**PLANNING COMMISSION**  
**Tuesday, September 11, 2018**  
265 Strand Street, St. Helens, OR 97051  
[www.ci.st-helens.or.us](http://www.ci.st-helens.or.us)

**CITY OF ST. HELENS PLANNING DEPARTMENT  
STAFF REPORT  
Conditional Use Permit CUP.2.18**

**DATE:** August 31, 2018  
**TO:** Planning Commission  
**FROM:** Jacob A. Graichen, AICP, City Planner

# ST. HELENS MULTIFAMILY DEVELOPEMENT

SDR3

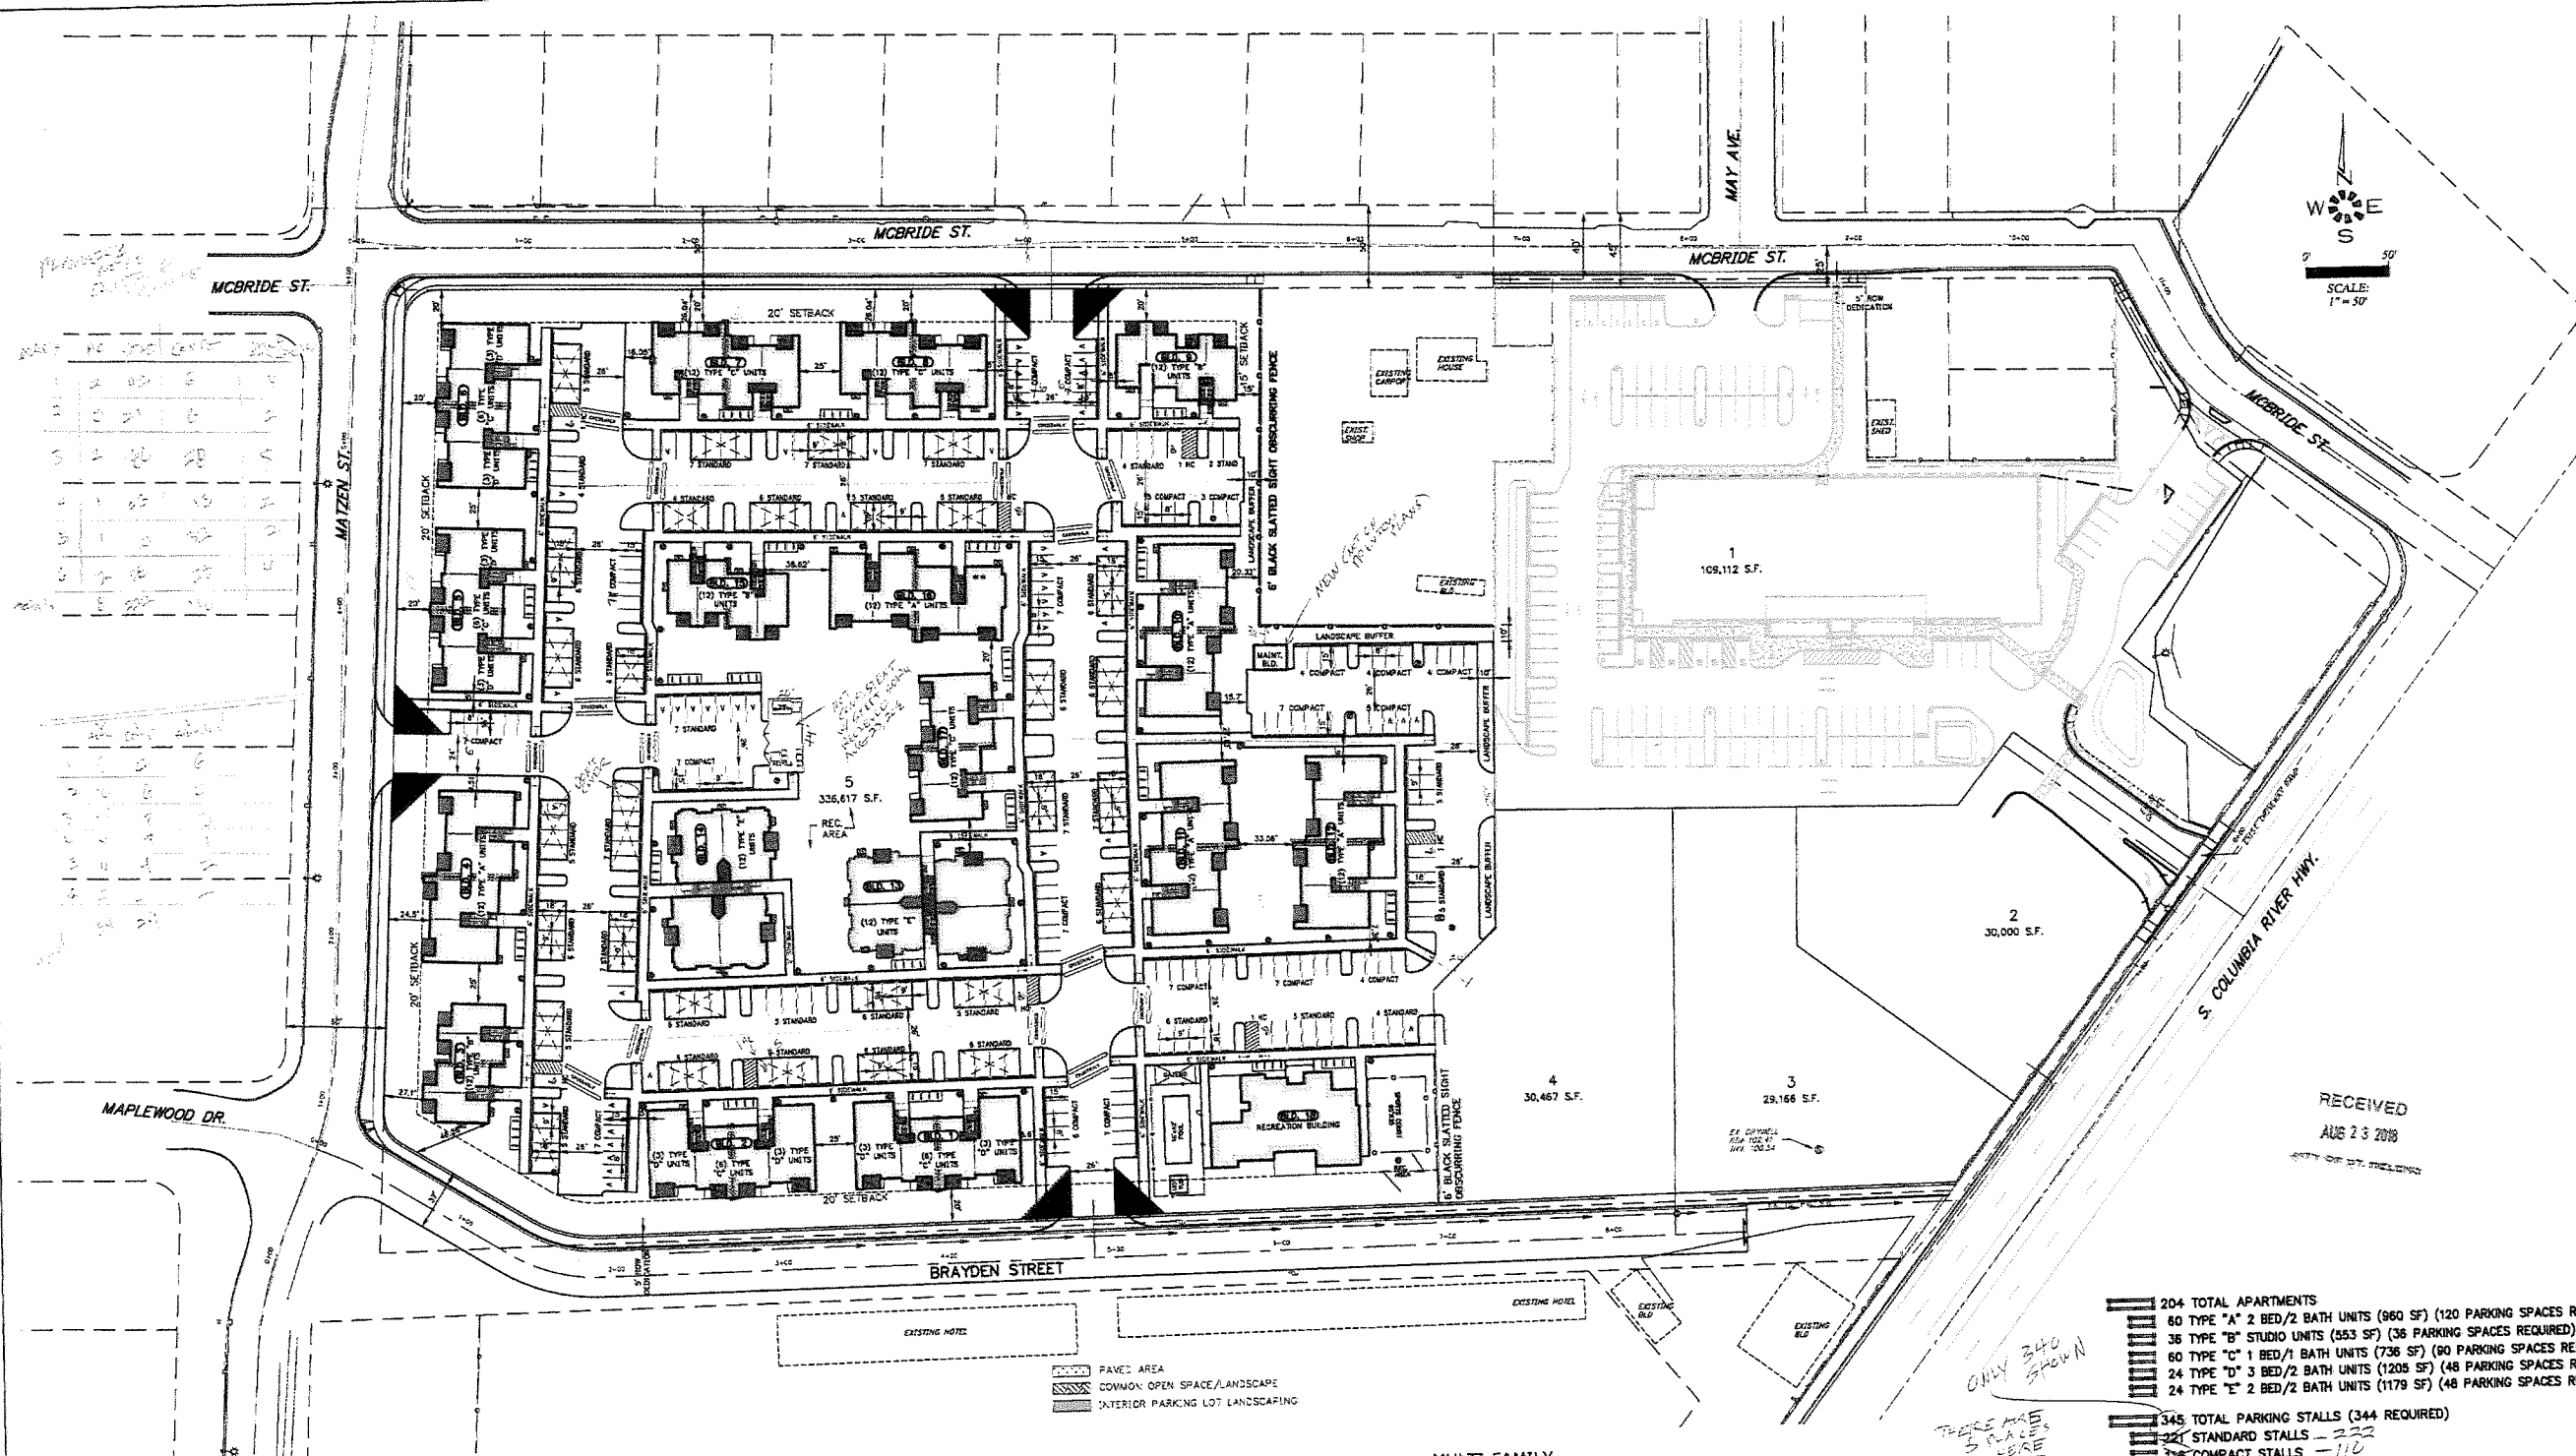
Minimum 20' yards (setback) are required along all public streets; plans comply. This includes the revised site plan SDR3 received on August 23, 2018.

The revised plans received on August 23, 2018 show 340 actual spaces. The text on the plans indicates there are 345 but in five places the parking stall count by contiguous row is off by one. The plans received August 23, 2018 are 4 spaces deficient.

Proposal as shown on the site plans (sheet SDR3 received August 23, 2018) is about 20' x 44' or about 880 square feet, which is insufficient. On sheet SDR4 (received August 23, 2018) its shown as 25' x 45' or about 1,125. Plans are inconsistent.

SDR3

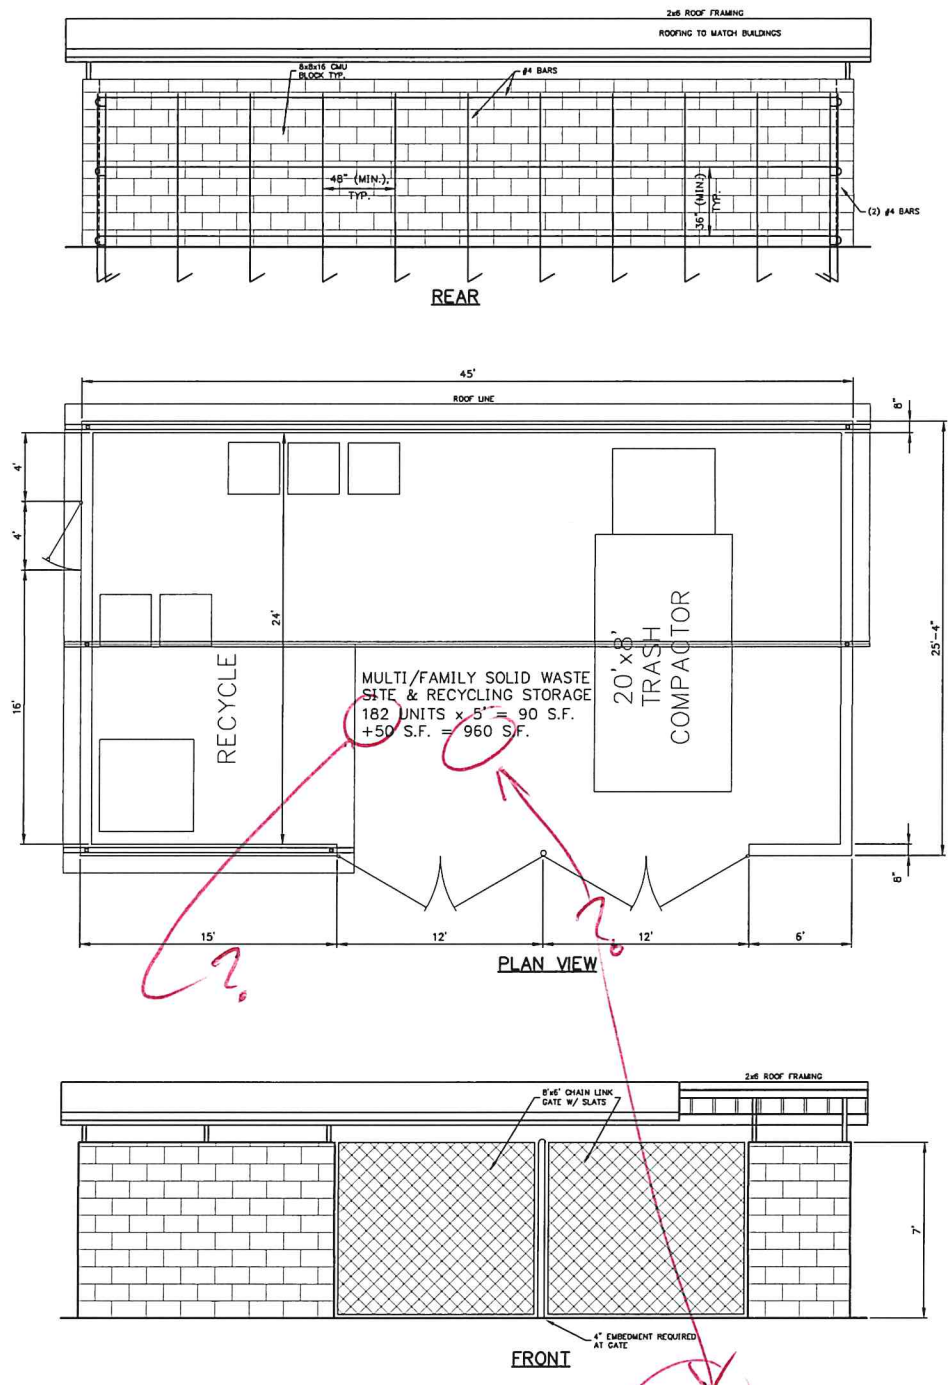
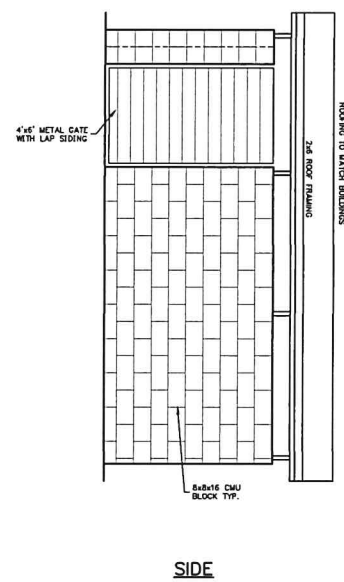
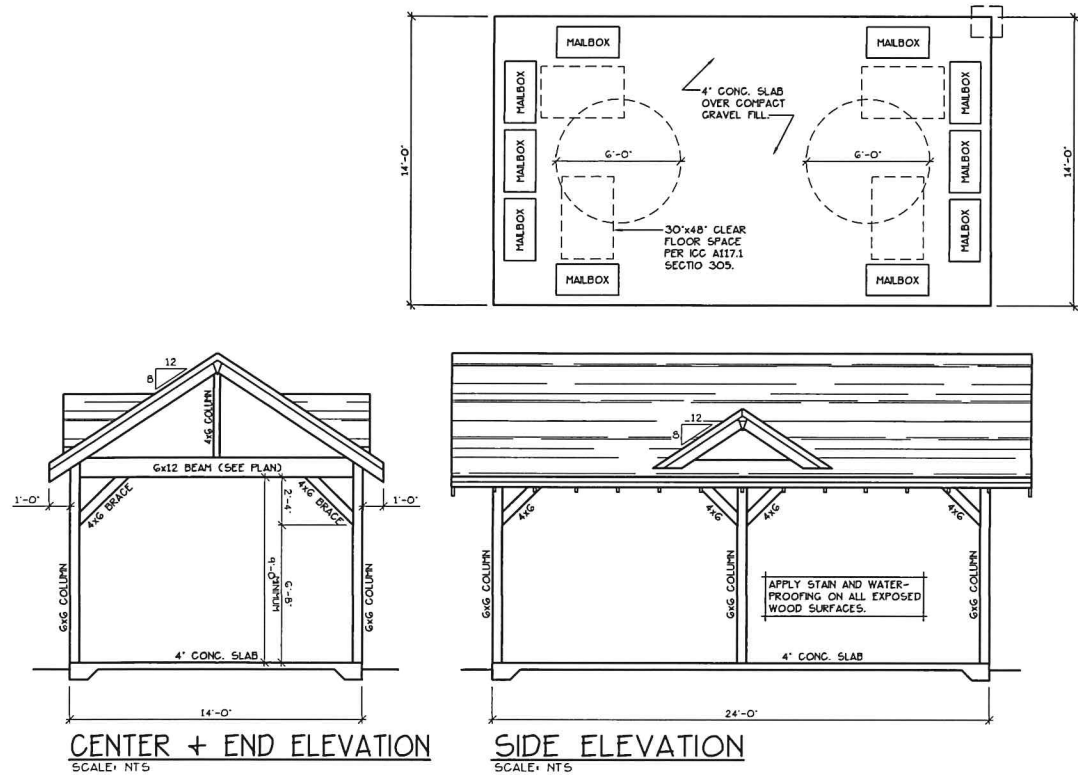
ONLY 340 SHOWN  
THERE ARE  
5 PLACES  
WHERE  
THE  
IS  
WRONG

**TRASH & RECYCLE ENCLOSURE (1,140 S.F.)**  
BETWEEN BUILDINGS #9 & #10

L1.5

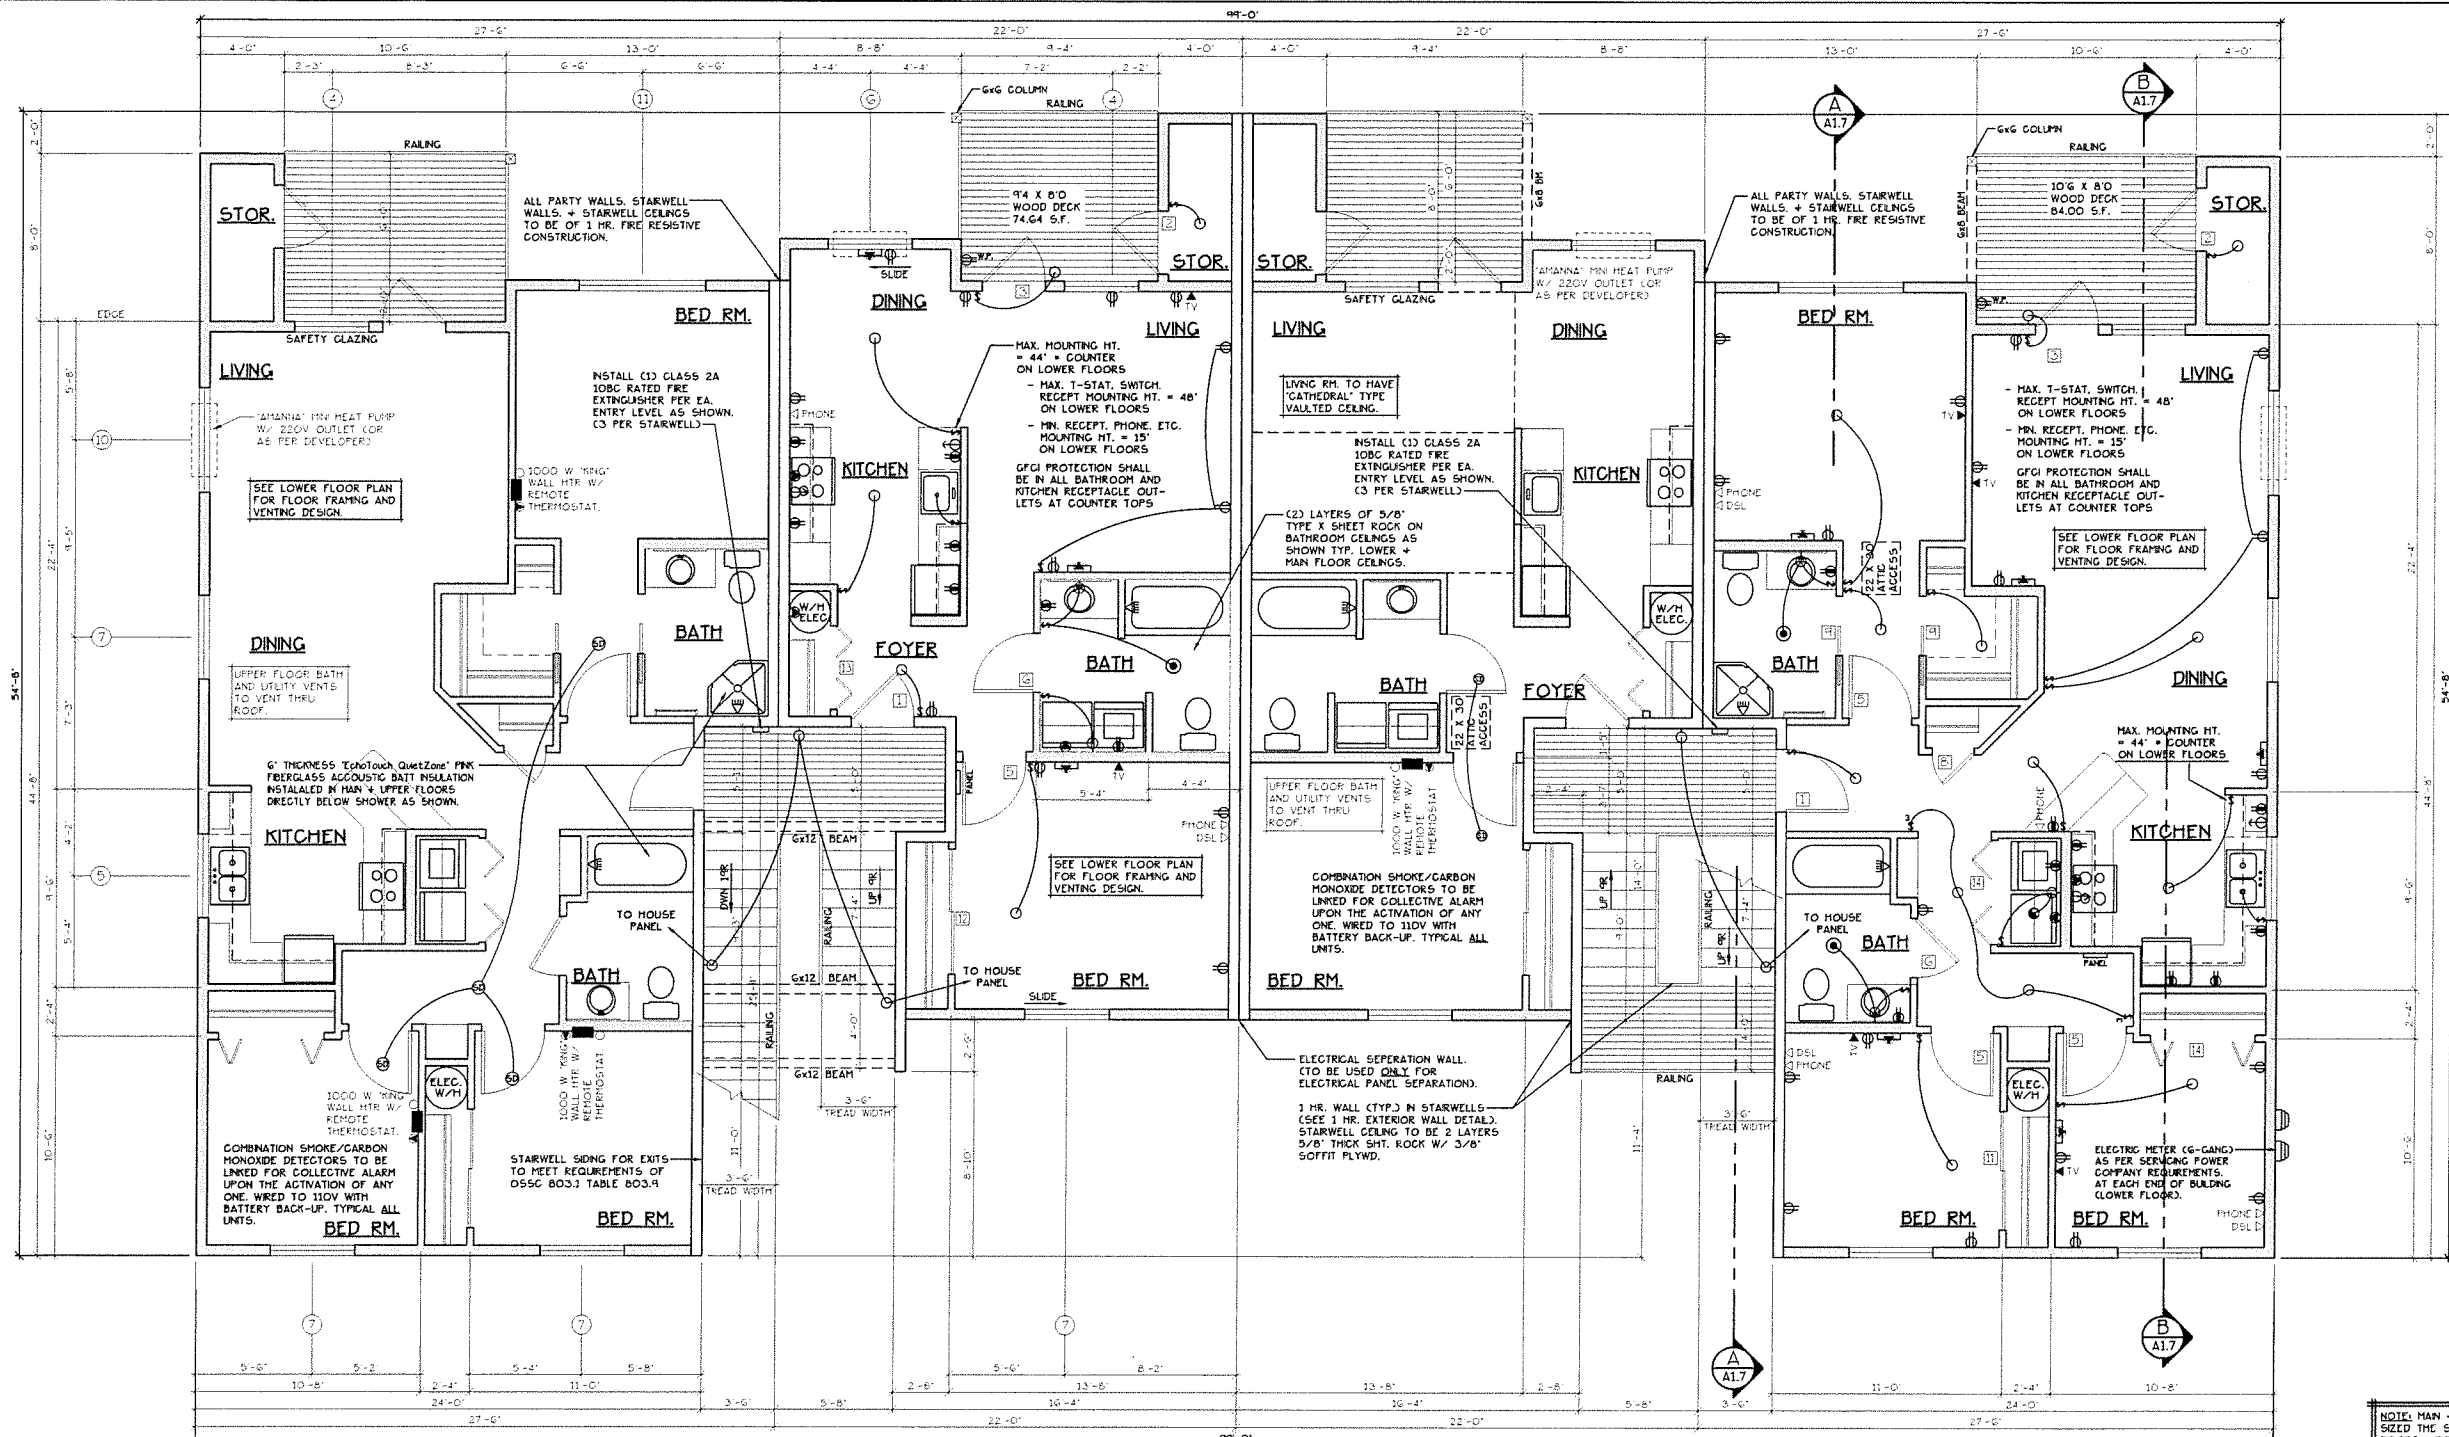
Except, on August 23, 2018, the applicant provided a detail buffer/screen from the R7 (165 McBride Street) property consisting of a mix of Columnar Dawyck Purple Leaf Beach (tree) and Texas Wax-Leaf Privet, in addition to a 6’ high black sight obscuring fence. This is an acceptable “in lieu” standard allowed per SHMC 17.72.070(3), provided no objection from the Commission or citizen.
